**Application for Planning Permission for  
Proposed Temporary Warehouse for Storage of Construction Materials and Associated  
Filling of Land for a Period of 3 Years at Lots 1445 S.B ss.2, 1445 S.B RP, 1489, 1490, 1492  
and 1494 in D.D. 76 and Adjoining Government Land, Ng Uk Tsuen, Sha Tau Kok Road,  
Ma Mei Ha, Fanling, N.T.**

**(Application No. A/ NE-LYT/868)**

**Table 1: Responses to Comments from Fire Services Department and Local Comments/Views on Planning Application No. A/NE-LYT/868 (11 March, 2026)**

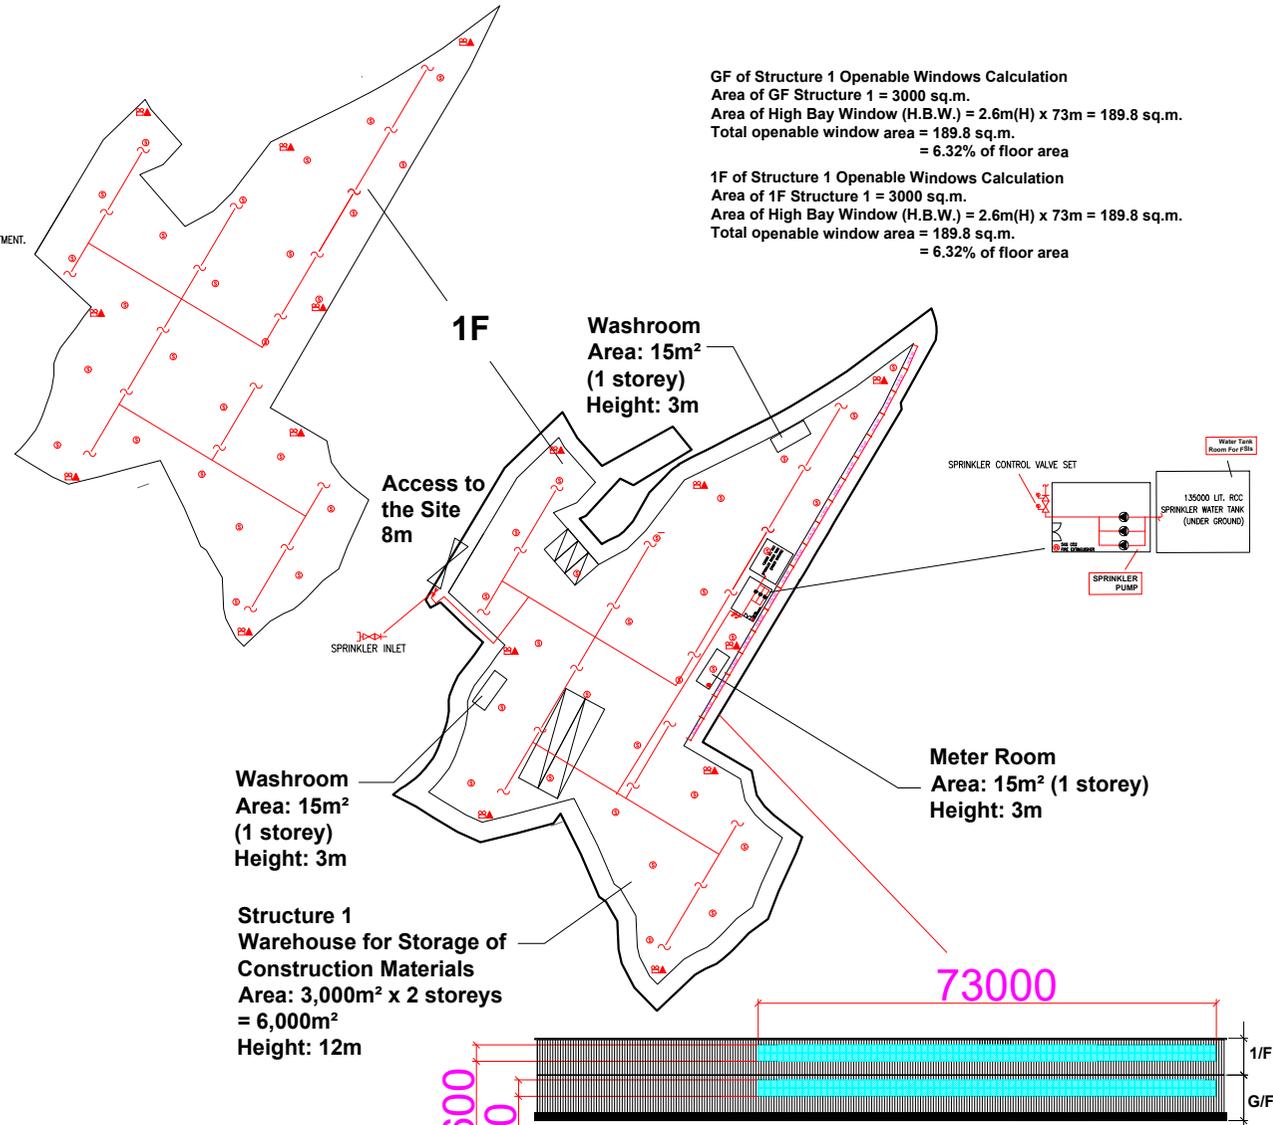
(1)	The sprinkler inlet shall be in a prominent position on the exterior of the building.	(1)	The sprinkler inlet is proposed in a prominent position on the exterior of the building (see the revised FSIs proposal attached).
